INITIAL FIRE SAFETY INSPECTION REPORT

Factory Name: Youngone (CEPZ) Ltd (Extension)

RSC ID: 24569

Date: 4th October, 2023

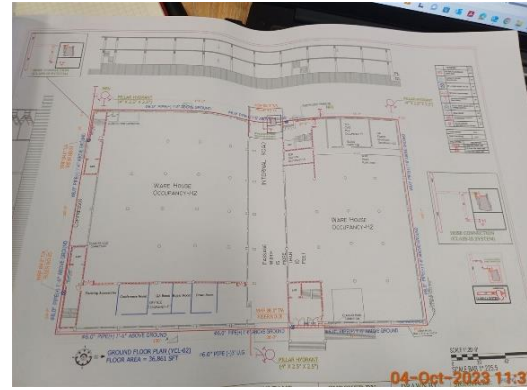
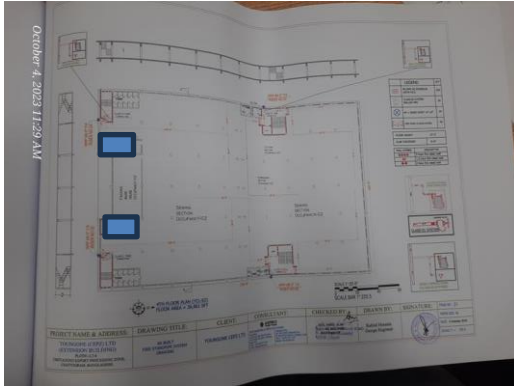
F-2	Fire Rated Construction	Floors to floor penetration due to expansion joint, PVC pipe and Cable riser are not properly separated by fire rated construction at all floor.	<p>Seal all penetrations and openings in floor/ceiling assemblies by a listed through-penetration fire stop system tested in accordance with ASTM E814 or approved alternative standard to maintain minimum 3-hr. fire resistance rating. Installation shall be as per manufacturer published installation guideline and the certification authority guideline to ensure the fire-rating.</p> <p>or,</p> <p>Provide a minimum 2-hr fire rated shaft to separate the penetrations/openings from each floor if required.</p>	Within 3 months
-----	-------------------------	--	--	-----------------

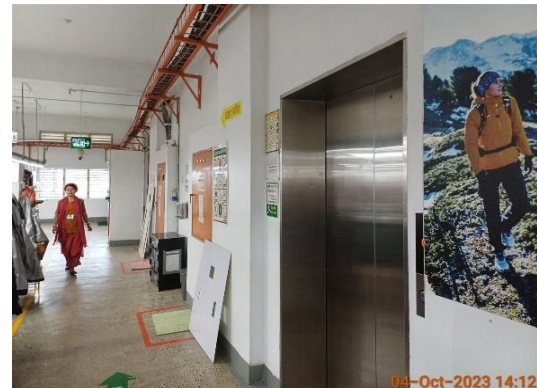
F-2	Fire Rated Construction	Elevator shafts are directly open into the inside of production floor.	Elevator shaft shall be separated from production area by 2 hours fire rated construction and opening protective. 2-hr fire barriers shall be protected with minimum 1.5-hr fire protective opening assemblies.	Within 3 months
-----	-------------------------	--	---	-----------------
